TECHNICAL BULLETIN

INTRAAX® AAL WITH LDA™ HEIGHT CONTROL VALVE KITS

SUBJECT: Change in HCV
lower mounting bracket

LIT NO: T89006

HCV lower linkage assembly with previous bracket

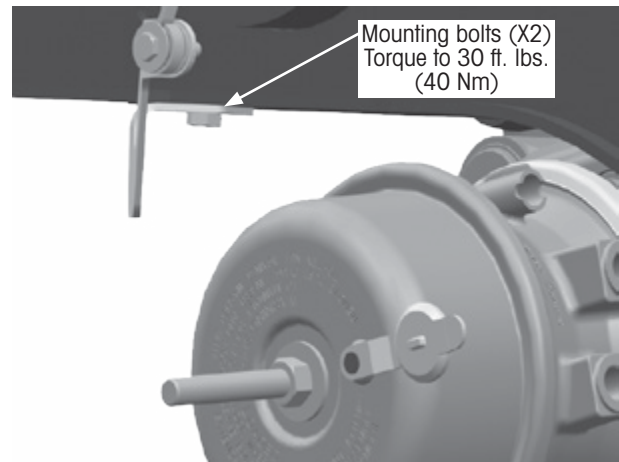
Hendrickson has identified that some AAL suspensions and HKARL sliders equipped with air-disc brakes may have potential contact with certain Height Control Valve (HCV) kits.

As shown below, the mounting remains the same. However, the shape of the bracket has been modified for greater clearance.

Effective February 29, 2016 the lower Height Control Valve (HCV) mounting bracket has been modified to provide an optimized solution for all suspensions.

AAL Large Diameter Axle (LDA) suspensions and HKARL sliders equipped with air-disc brakes and fitted with a HCV kit manufactured between January 2013 and February 2016 should be inspected for a potential contact between the current lower HCV bracket and roadside brake chamber.
